D/DRC Case

1401-1431 Assembly Street & 1011-1019 Washington Street

DESIGN/DEVELOPMENT REVIEW COMMISSION
DESIGN REVIEW DISTRICT
Case # 1

NATURE OF REQUEST: Request for Certificate of Design Approval for new construction of 15-story residential building

DETAIL VIEW OF NORTH FAÇADE – OPTION 01

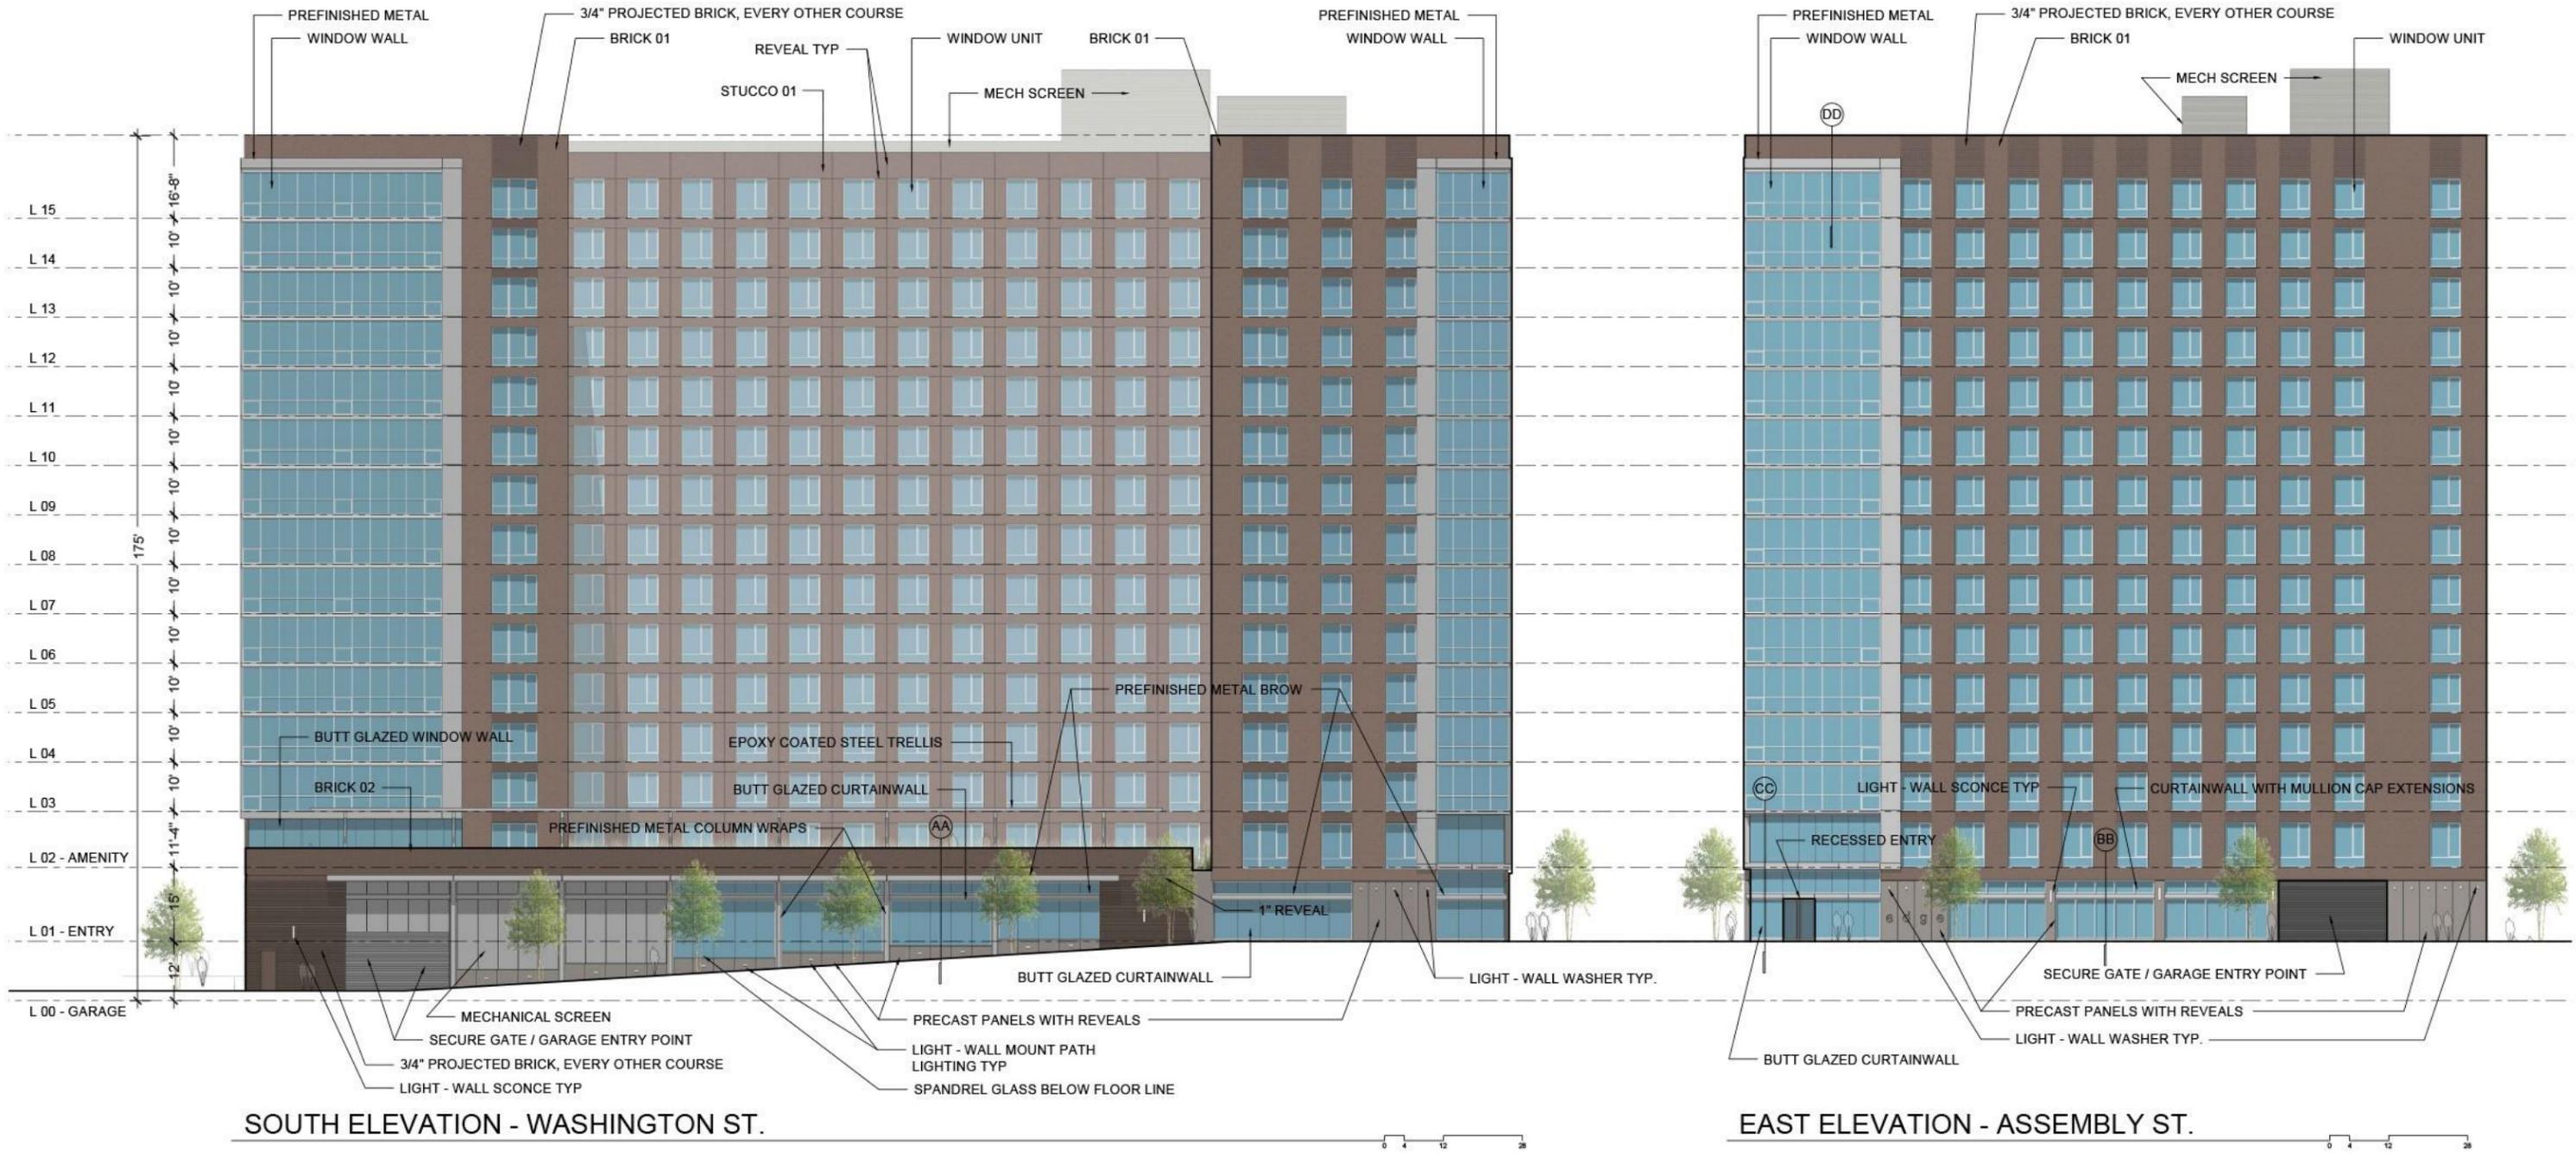
The applicant was able to recess the stucco façade on the north elevation back from 12" to 16" to emphasize the change in materials and break up the massing a bit more. Two options have been provided, the first one showing one color of stucco and the second showing a two-color option on the north façade. The first option is a simpler expression of the material, and emphasizes the window openings more; staff supports option one as more successful.

Staff still has significant concerns with the Washington Street façade, particularly the lack of a two-story mass; otherwise the project substantially meets the design guidelines. Staff recommends an approval of the request, with option one color palette on the north elevation, conditional upon further exploration of the Washington Street façade.

SOUTH ELEVATION - WASHINGTON ST.

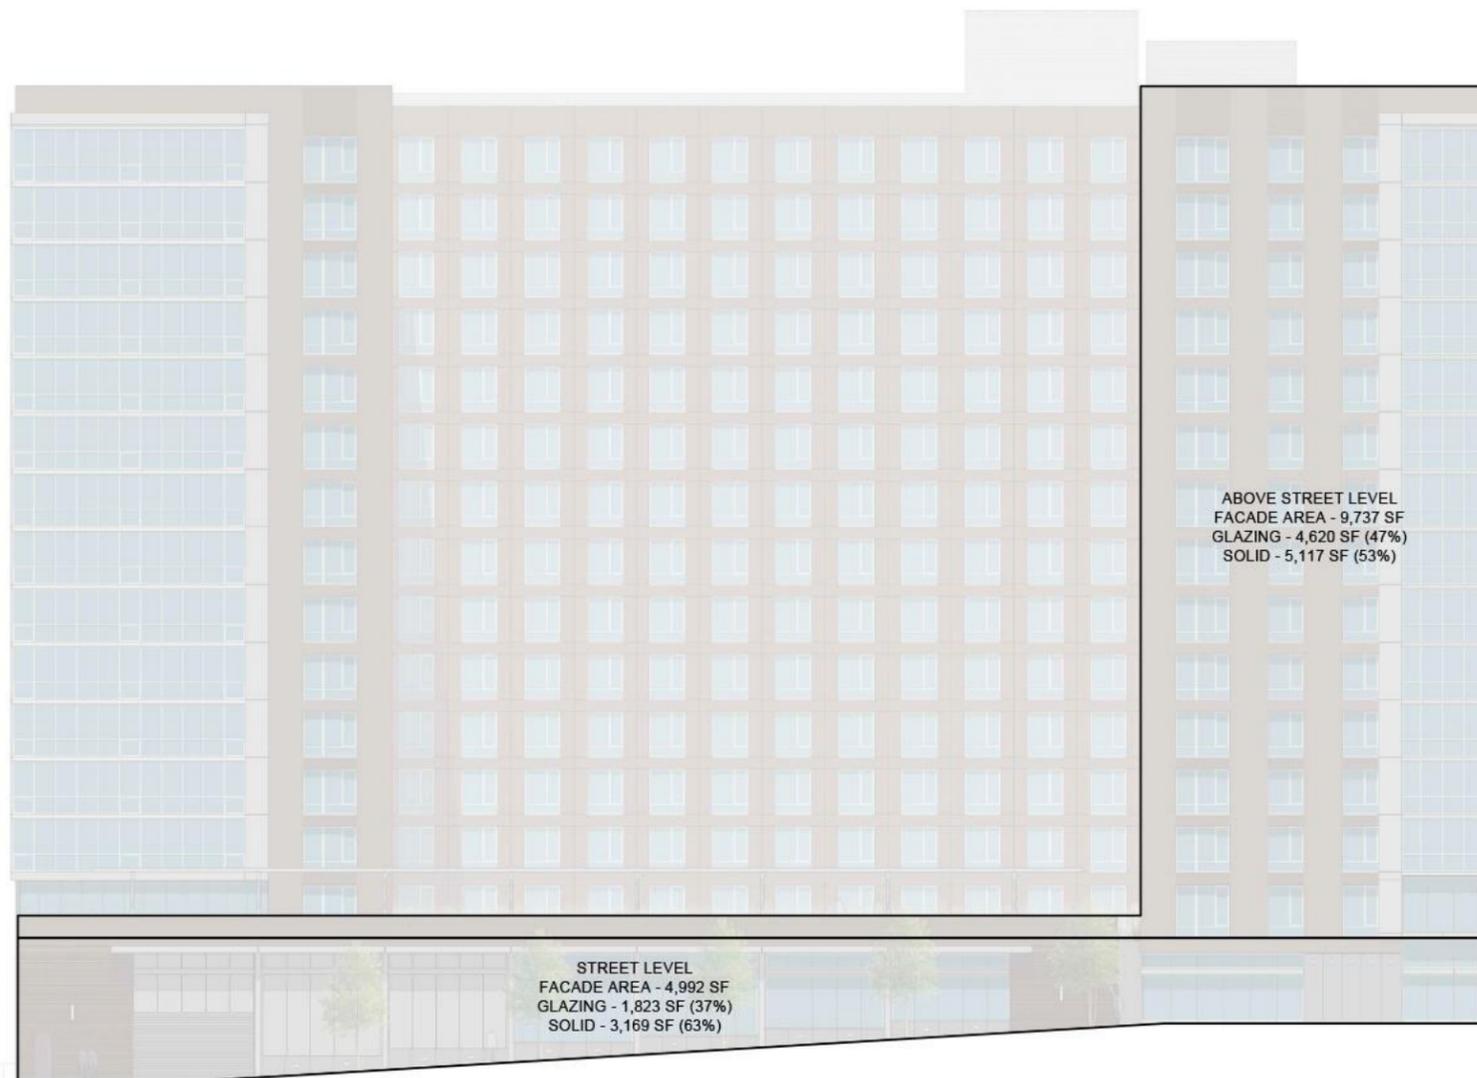
While pushing much of the 15-story massing back from the sidewalk does prevent the building from overwhelming the Washington Street section, there is a lack of transition in scale from the tower elements to the one-story volume along this streetscape. The massing could provide a more effective transition in scale if the Washington Street element were 2-4 stories, rather than one. The steel trellis and amenity deck

While the overall building is 15-stories, the one-story element along Washington Street is not in scale with the remainder of the building. Having a volume of at least 2-stories would hold the street edge better and be more consistent with this guideline.

The proportion of openings on the Assembly Street façade is 49% storefront/51% upper floors. The Washington Street façade has 37%/47%, respectively. The upper floors have a sufficient proportion of openings, however much more is needed on the ground-level frontage, particularly on Washington Street, where about a third of the storefront area is dedicated to garage/service area.

DTL @ WINDOW HEAD @ STUCCO
 3" = 1'-0"

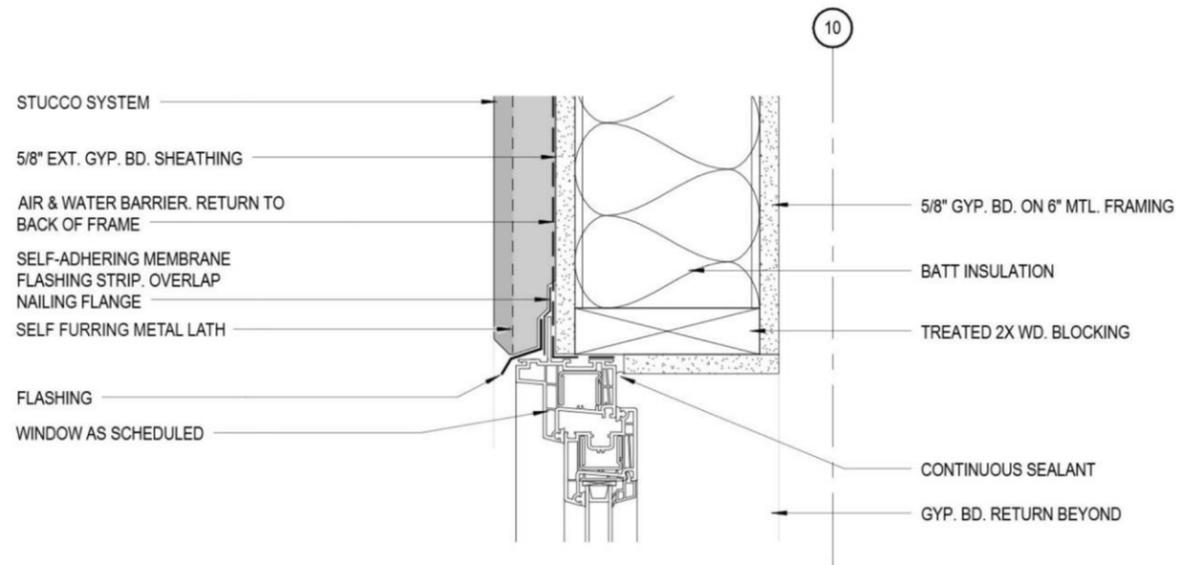
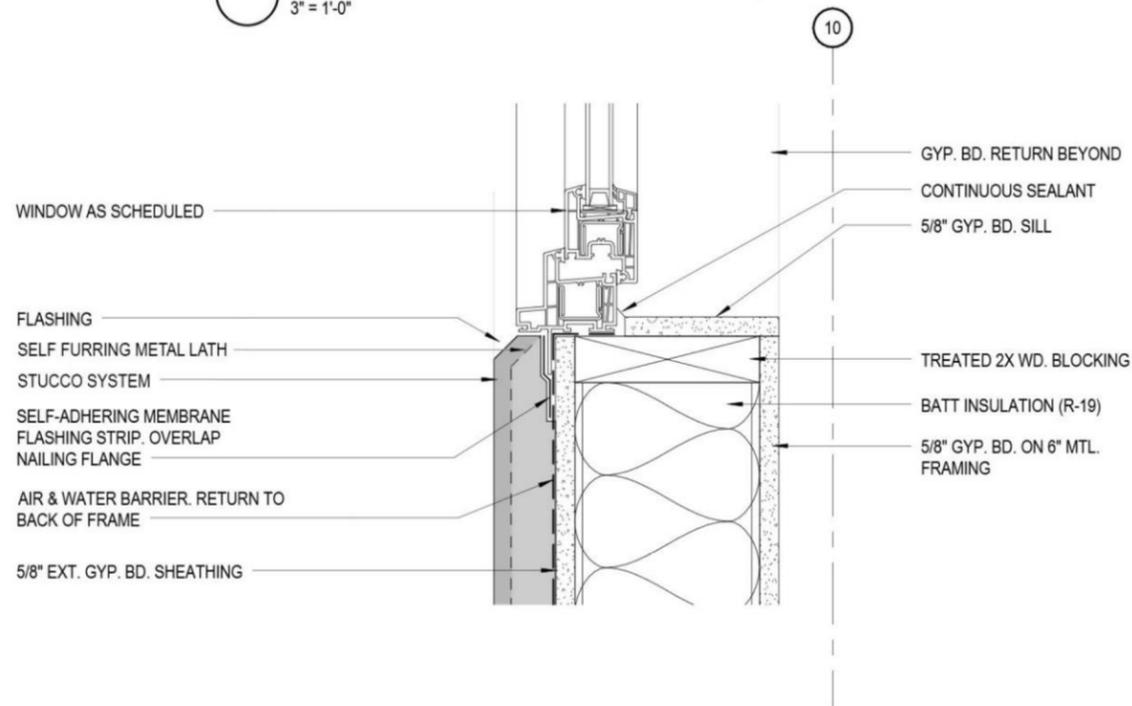
The stucco window section shows a 1 ½” depth, which is typical for this material. Section/elevations should be provided for the east and west elevations that face into the courtyard.

DTL @ WINDOW HEAD @ BRICK
 3" = 1'-0"

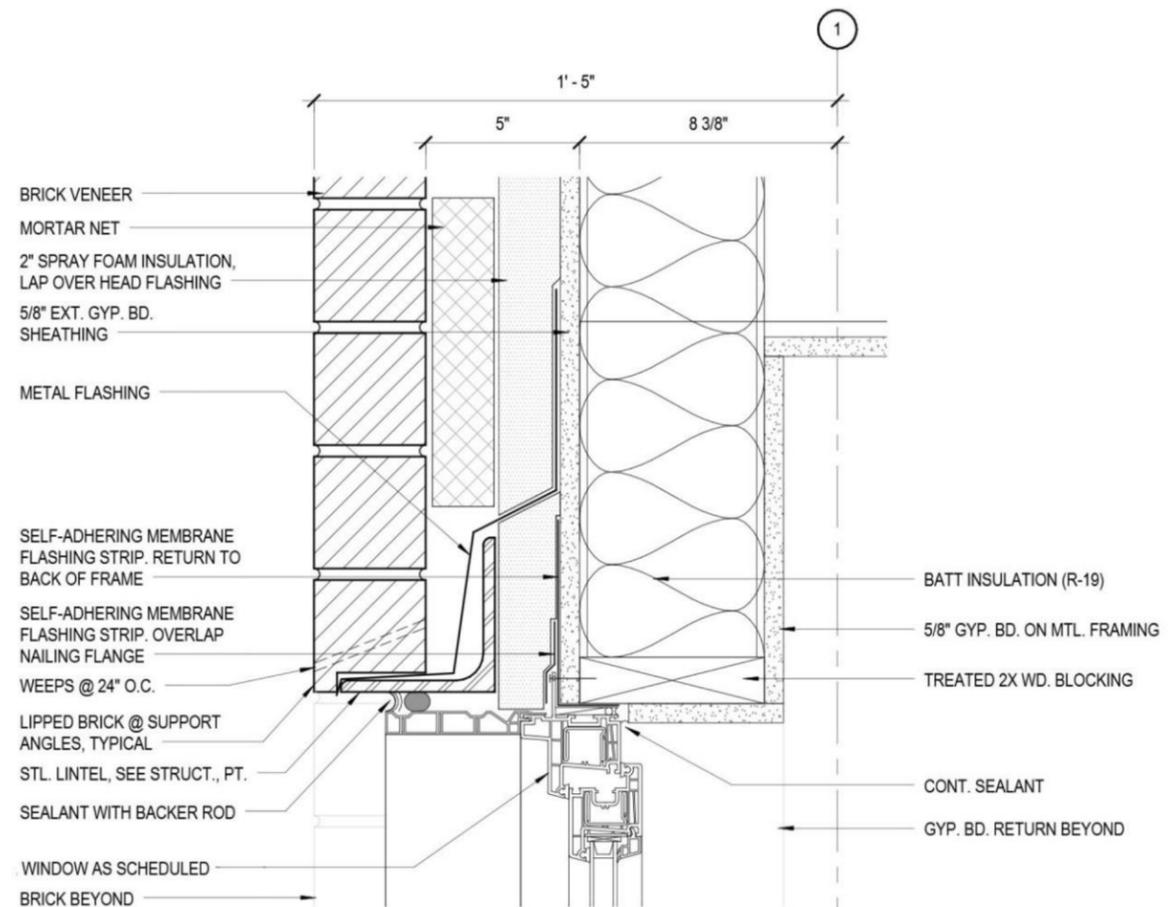
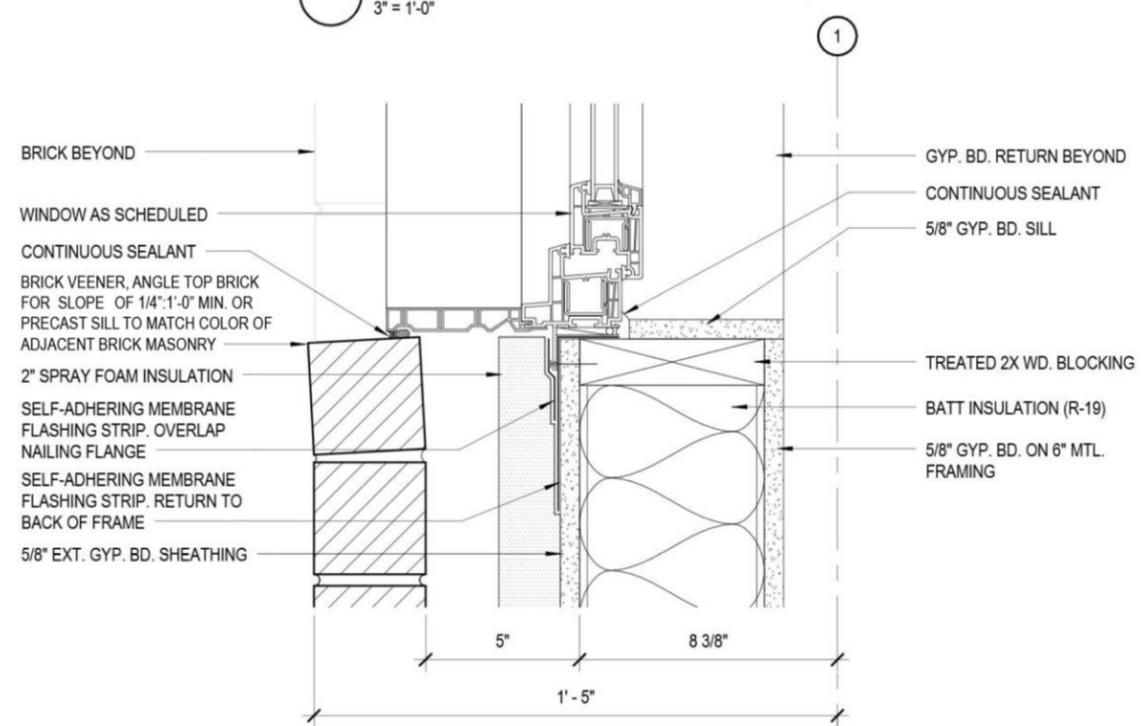
The key to articulating the massive upper façade and the regular pattern of windows is the depth of the window section. The applicant has provided detailed sections of the window configurations. The punched window sections in the brick show a 5” depth with the brick depth and the window frame trim. This is a good depth that should have a distinct shadow line. It is critical that this detail remain part of the design throughout value engineering, and construction documentation.
